# Access Compliance Report

## Public Rights-of-Way

### (Curb Ramps)

Intersection ID: 49130	Main Street: AUBURN_HILL_LN	Cross Street: WILTSHIRE_RIDGE_LN	Location: NW
ADA ID: AE196D99D86B	Ramp Type: Perp	Initial Pass/Fail: Fail	Overall Compliance: No
Severity Score: 8.75			
Codes/Mitigation Info/Possible Solution		Field Measurements/Component Compliance

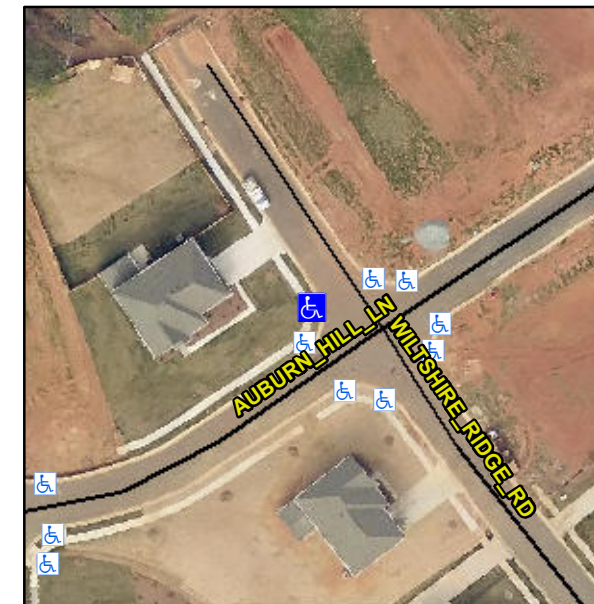
**Not Found, R304.5.1**

Compliance	Description	Data	Compliance	Description	Data
N/A	Ramp Length (in)	48.5	Yes	Ramp Slope (%)	5.0
No	Ramp Width (in)	45.0	Yes	Ramp XSlope (%)	0.5
N/A	Flare Type LT	N/A	N/A	Flare Type RT	N/A
N/A	Flare Slope LT (%)	N/A	N/A	Flare Slope RT (%)	N/A
N/A	Flare Traversable LT?	N/A	N/A	Flare Traversable RT?	N/A
N/A	Landing Length (in)	N/A	N/A	DWS Provided?	N/A
N/A	Landing Width (in)	N/A	N/A	DWS Contrast?	N/A
N/A	Landing Slope (%)	N/A	N/A	DWS Length (in)	N/A
N/A	Landing X Slope (%)	N/A	N/A	DWS Full Width?	N/A
N/A	Landing Curb? (Y/N)	N/A	N/A	DWS Offset (in)	N/A
N/A	Shared Landing?	N/A			
N/A	Gutter Ponding?	N/A	N/A	Gutter Slope (%)	N/A
N/A	Gutter Lip Ht (in)	N/A	N/A	Gutter X Slope (%)	N/A
N/A	Painted X Walk1?	No	N/A	Painted X Walk2?	N/A
	X Walk 1 Direction	To E		X Walk 2 Direction	N/A
N/A	X Walk 1 Width (in)	N/A	N/A	X Walk 2 Width (in)	N/A
	X Walk 1 Slope (%)	4.2		X Walk 2 Slope (%)	N/A
	X Walk 1 X Slope (%)	0.8		X Walk 2 X Slope (%)	N/A

**Remove & Replace Entire Ramp.**
